MEMORANDUM

From:	Brigitte Crafer Landscape Architect	To (Case Officer):	Kieran Neumann
Service	WBC Landscape and Trees	App No:	242665
Address:	Land west of Kingfisher Grove, Three Mile Cross.		
Type of Development:	Major Dwellings (10+)		
Proposal:	Application for approval of Reserved Matters pursuant to Outline Planning Consent 201002 (approved under appeal ref. APP/X0360/W/22/3304042 dated 31/01/2023) for the erection of 49 no. affordable dwellings with associated drainage and attenuation, open space and landscaping. Details of appearance, landscaping, layout and scale to be considered, plus details for discharge of conditions 11, 12, 13, 15 and 16 from the Outline permission.		
Site Visit Made:	Yes/No

Fig. 1

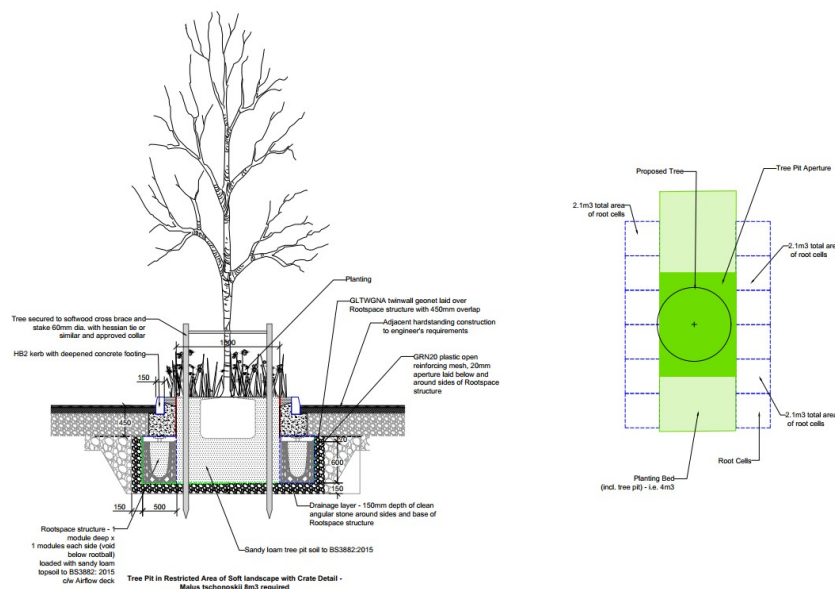
- I am concerned about the viability of the specified trees between parking bays – although I note the use of the very narrow Hornbeam selected which is a good choice, I am concerned that where these are surrounded by hard landscaping they will have a restricted rooting area, and a slightly different tree pit to those submitted which have been used elsewhere on Council development sites may be preferable (see Fig. 1 below) which would provide a greater area of rooting volume?
